95 EAST 1ST AVENUE (COMPLETE APPLICATION)
DE418872 - Pending Zone CD-1

EXECUTIVE SUMMARY

DEVELOPMENT PERMIT STAFF COMMITTEE RECOMMENDATION: APPROVE

A1.01

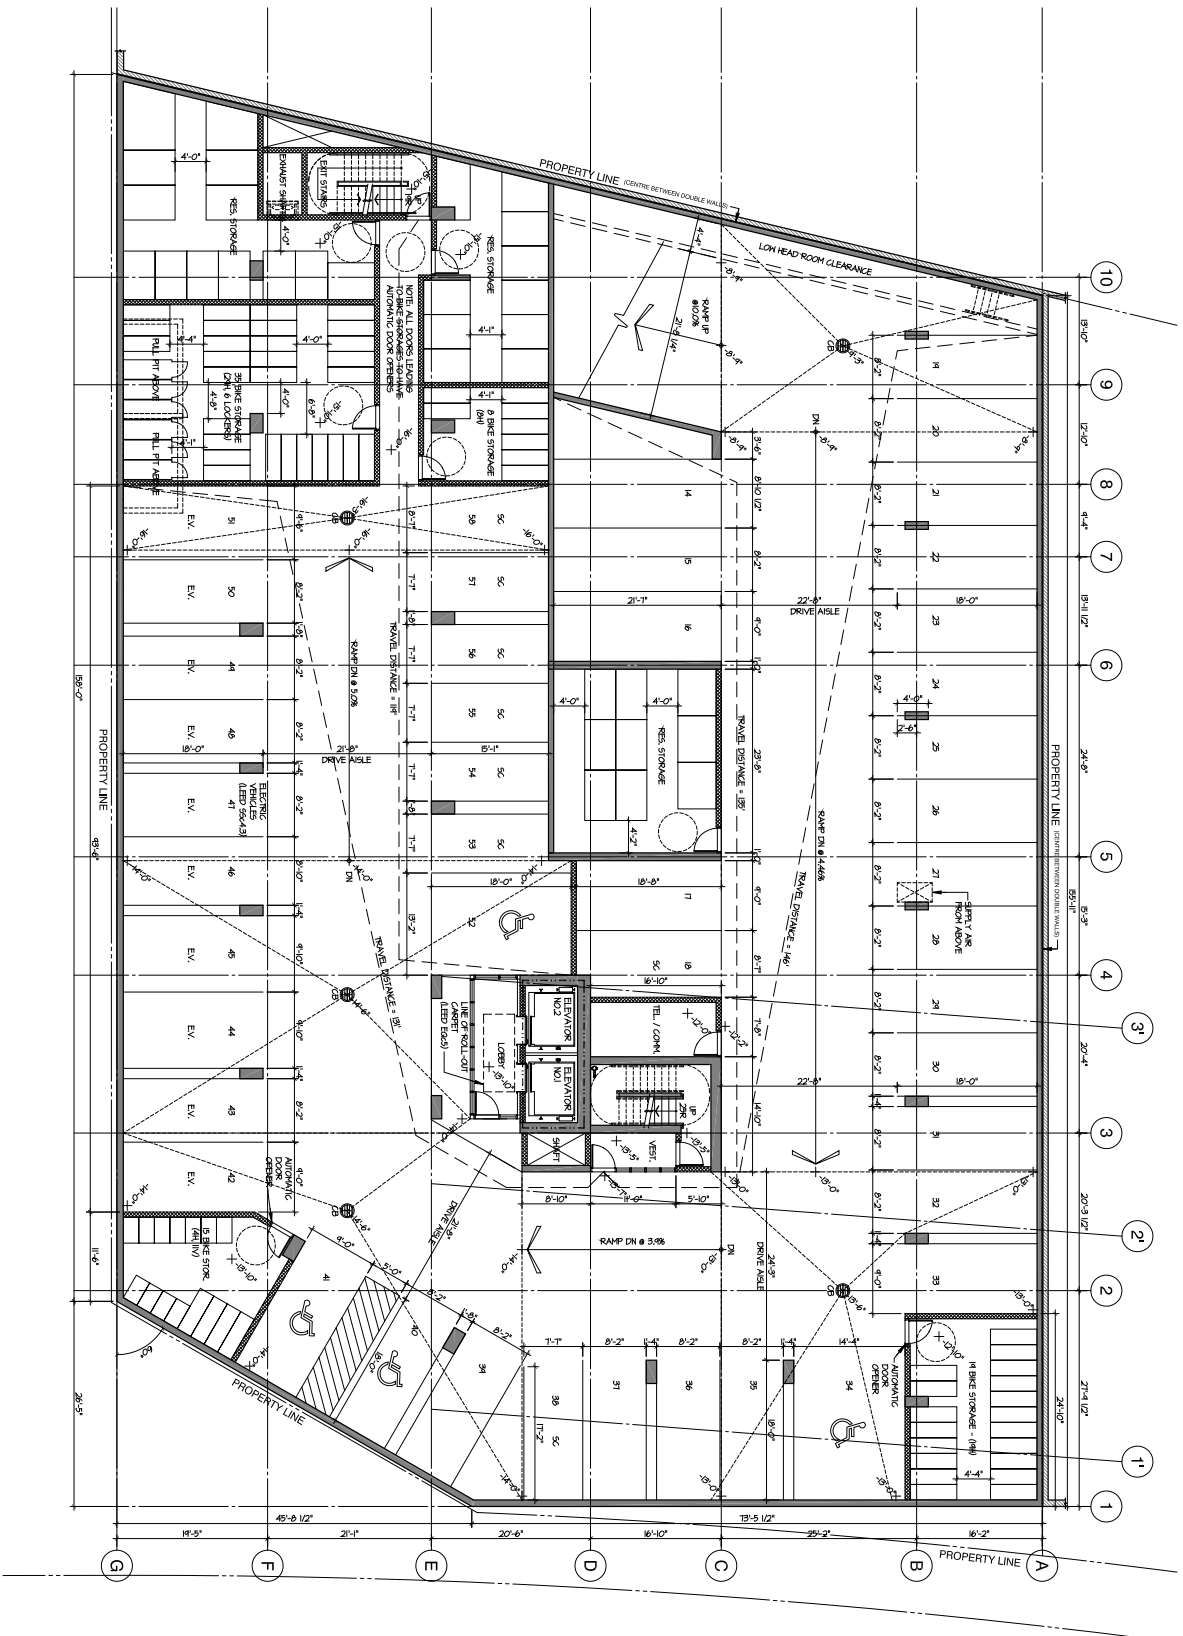
Rezoning Condition A.(b).3:	Design development to incorporate all vehicular access ramps into underground parking garages be architecturally integrated with a building, thereby reducing their visual impact as experienced from the public realm.
Applicant Response:	The applicant has provided some trellis work over the exposed parking ramp.
<u>Staff Assessment:</u>	In the review of the vehicular access ramp, staff note the exceptional constraints of this site in light of the programme. As such, staff recognize that for Building 1, the provision of an architecturally-integrated vehicular access ramp cannot be achieved without sacrificing the provision of a few dwelling units. Nevertheless, Standard Condition A.1.3 requires further design development on the treatment of the parking ramp, in order to minimize its visual impact on the surrounding public realm.

A.1.3 design development to the proposed parking ramp treatment to add visual amenity by: improving on the proposed trellis design; adding in creeping vines on the trellis; and by adding a textured treatment to the walls against the ramp by lining it with brick or a customized poured concrete pattern;

OVERALL LANDSCAPE PLAN

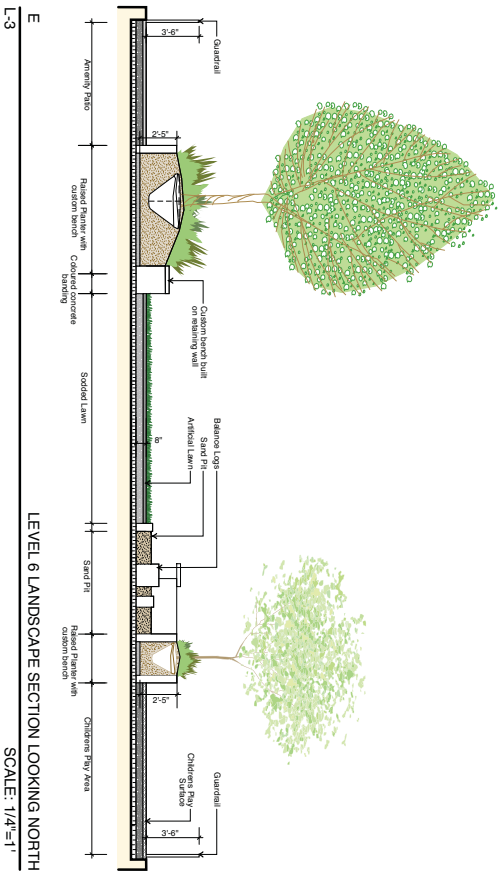
- i. deletion of all landscape on street rights-of-way in front boulevards, bulges and tree bases etc. as shown on drawing L2;
- ii. provision of sodded lawn in the front boulevards with street trees;
- iii. provision of decorative tree grates at the base of the trees in the plaza;
- iv. provision of concrete in the bulge at the intersection of 1st and Pullman Porter Street complete with bike racks;
- v. deletion of the planting proposed along the retaining wall in the plaza at the corner of 1st and Quebec and relocation of the benches against the wall.

Note to Applicant: As proposed, with planting against the wall and benches in front of the planting there is only 3'-0" of space to walk between the bench and the planting under the trees along people's diagonal desire line for walking across the corner;

- vi. deletion of the single row of planting (Butterfly Lavender) proposed between the wall and 'L' shaped bench on 1st Avenue on private property.

Note to Applicant: The proposed planting will grow and make the bench unusable;

- vii. deletion of Butterfly Lavender and provision of low growing groundcover such as Common Bearberry in the planters along Pullman Porter.

- viii. provision of a planter wall of a maximum height of 24" along the sidewalk on Pullman Porter Street.
